Re: Westtown School – 975 Westtown Road  
Revised Conditional Use Application Materials – Athletic Field Lighting

**Responses to Cedarville Engineering Review Letter of April 14, 2023 (REISSUE):**

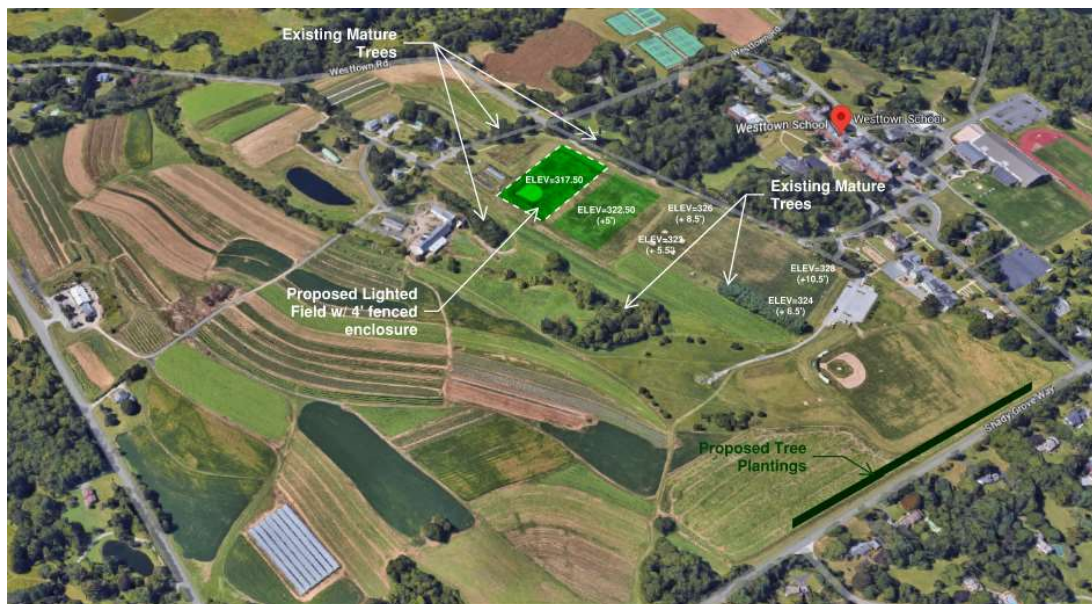
- *The acoustics study letter prepared by Eberbach Acoustics Consulting Consultants shall be revised to address the following:*
  - *The referenced study indicates that noise measurements were based upon an assumption of a soccer practice of up to 56 players. The proposed parking lot proposes a total of 84 parking spaces required, resulting from the potential of a higher intensity use than assumed in the study. The study shall be updated, and shall be revised to be based upon full occupancy of the proposed parking space and existing spaces located to the east of the existing multipurpose fields, adjacent to the proposed fields.*

The number of players/participants referenced in the acoustics study is 56, which is a reasonable estimate of the number of people that will be utilizing the illuminated athletic field at any point in time. Even if the number of players/participants is doubled to 112, the noise produced would be an increase of only 3 decibels, as described in paragraph 4 of the January 26, 2023 letter from Everbach Acoustics Consulting. The number of proposed parking spaces is not necessarily representative of the number of people utilizing the illuminated athletic field at any given point in time, as the parking area is designed to accommodate the use of both athletic fields during daytime use. However, even if every car contained two players/participants and the total of 84 parking spaces produced 168 players/participants, the total increase in field noise would only be 4.77 decibels higher than the 56 players/participants quoted in the study, resulting in a reasonable noise level on the Property.
